# Technical Bulletin

## TCK42CRD - 2.5 YD25DDTi

### Design Differences Between FAI and Original

TB0055

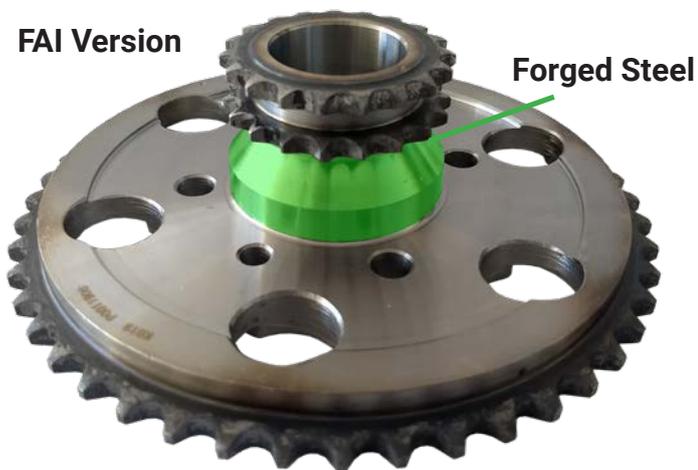
The image below shows the injection pump sprocket which has been manufactured by FAI compared with the original manufacturer design.

The sprocket supplied by FAI is a direct replacement with the only difference being the material & production methods used during manufacture.

The FAI design is strengthened by using forged steel rather than powder metal. Due to the added strength of the FAI version, the junction between the duplex and the simplex sprockets doesn't need the additional material, as indicated below.
